<b>Docket Number:</b>	17-BSTD-02
<b>Project Title:</b>	2019 Title 24, Part 6, Building Energy Efficiency Standards Rulemaking
<b>TN #:</b>	222596
<b>Document Title:</b>	Hwakong cheng Comments Laboratory Exhaust Fan Power
<b>Description:</b>	N/A
<b>Filer:</b>	System
<b>Organization:</b>	Taylor Engineering/Hwakong cheng
<b>Submitter Role:</b>	Public
<b>Submission Date:</b>	2/16/2018 5:32:16 PM
<b>Docketed Date:</b>	2/20/2018

## **Laboratory Exhaust Fan Power**

To: CEC  
From: Hwakong Cheng  
Subject: Comments on Prescriptive Requirements for Laboratory Exhaust Fan Power  
Date: February 16, 2018

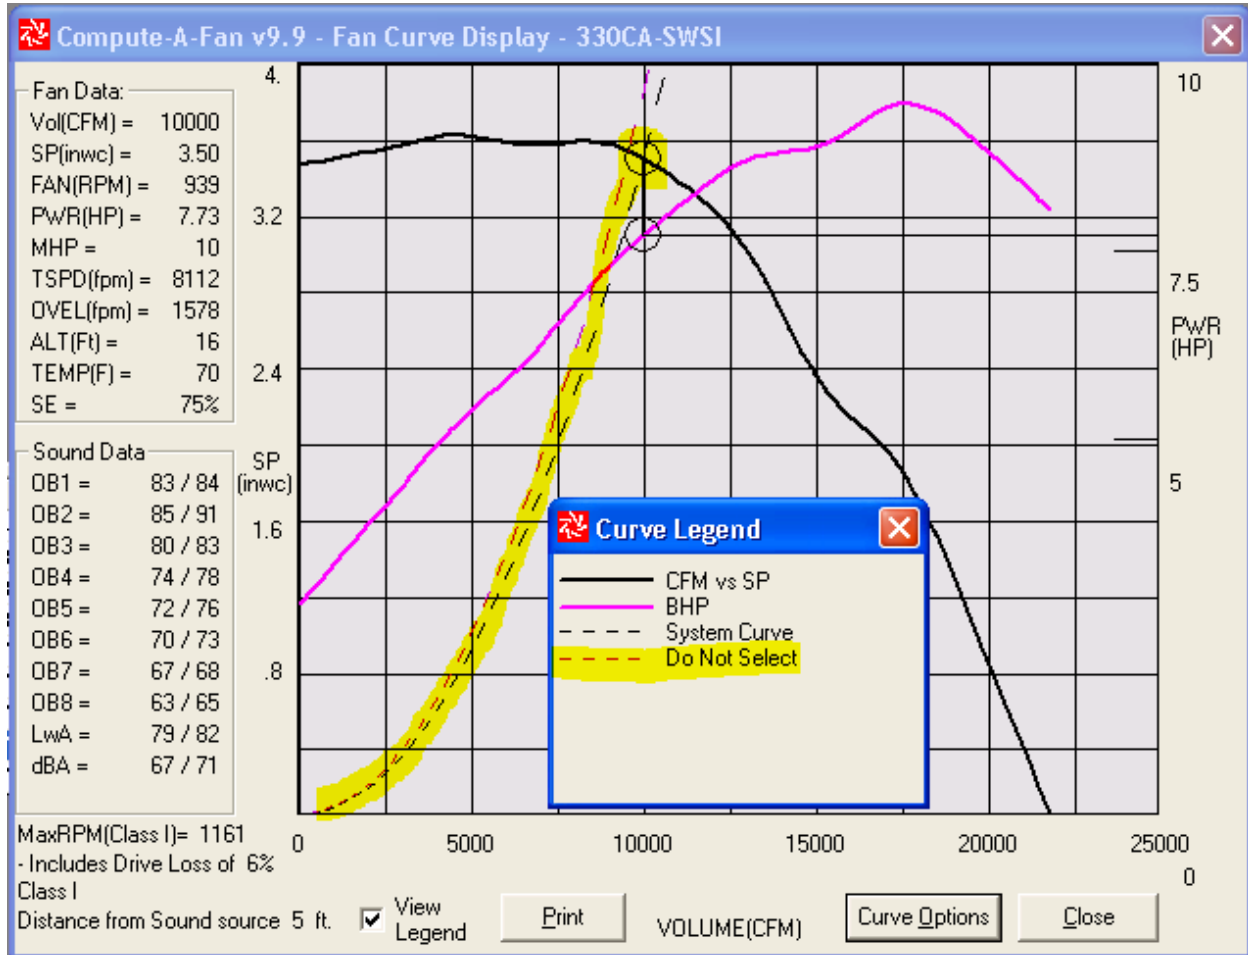
Utility fan selections for 10,000 CFM, 3.5" SP (lower than baseline described in CASE report), assuming 90% motors and 97% VFDs. Three of the fans can meet the 0.65 W/cfm limit.

The fan curve for one of the selections that meets the 0.65 W/cfm limit is shown below – the design operating point and fan system curve fall right on the “Do Not Select” line. This is not a practical fan selection.
